**CERTIFICATE OF APPROPRIATENESS**

**Property:** 1215 Rutland Street, lot 14, block 183, Houston Heights Subdivision. The property consists of a vacant 4,356 square foot (33' x 133') interior lot.

**Proposal:** New Construction – Residence *REVISION*

**EAST ELEVATION – FRONT FACING RUTLAND**

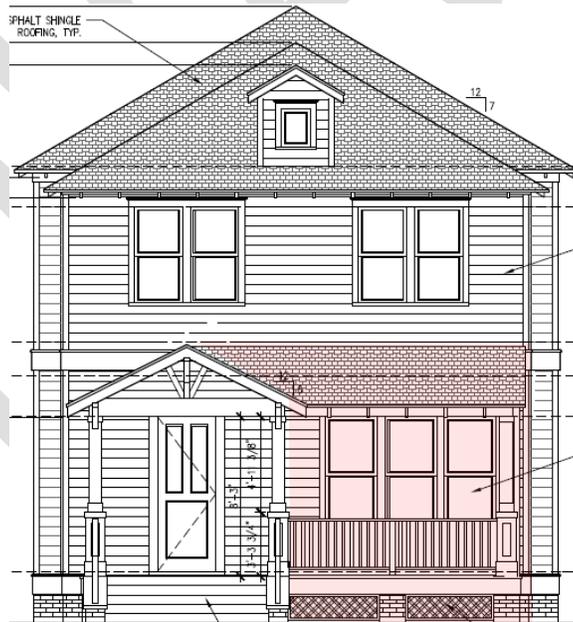
**Proposed Revision:** The half width front porch will be replaced with one that will now span the full width of the front wall. The revised porch will measure 22' 6" wide by 6' 6" deep.

**NORTH SIDE ELEVATION**

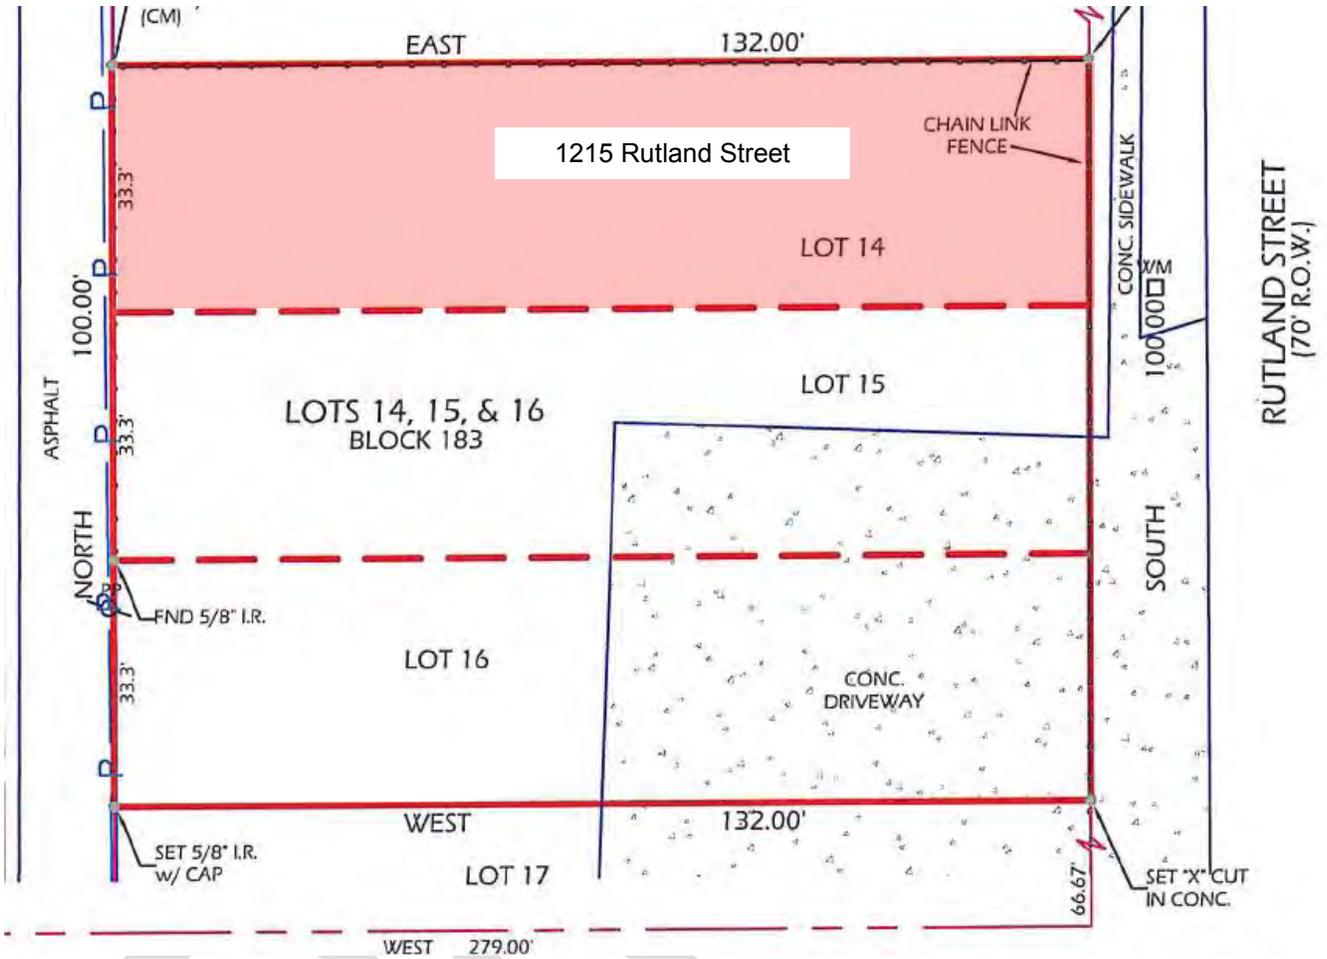
**Proposed Revisions:** Reduce the depth of the residence and attached garage by 5'. The eave height of the approved attached rear garage will be reduced from 19' 6" to 18' 6". The ridge height of the garage has been reduced from 27' to 25' 10".

**Proposed Revision:** Setback has been increased to 20' from the front property line.
